PREVOST PRODUCT CHANGE NOTICE

SPLINED DISCS REGULAR OPTION

ECN :2019155 rev:

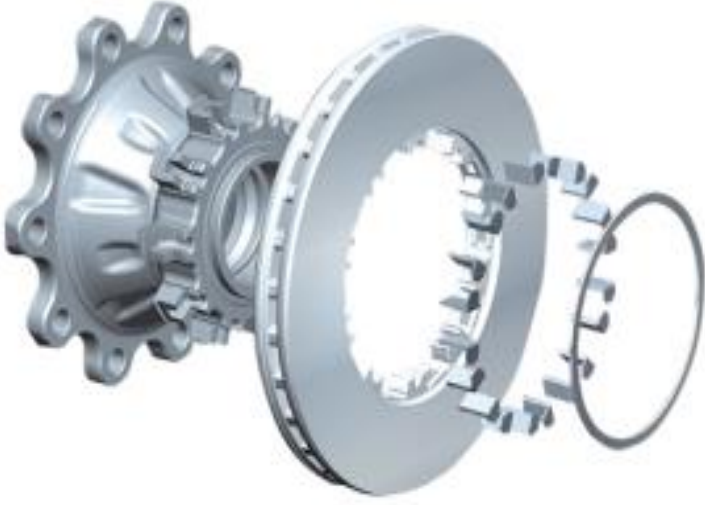
DESCRIPTION: Splined discs now available on regular option

REASONS (WHY): Provide an option for customer who may have problem with regular rotors.

- More even braking force and high torque capacity
- Reduce rotor cracking
- improve braking response
- Bigger ventilation of the system

- Retro fit kit #144982 IS-09085A
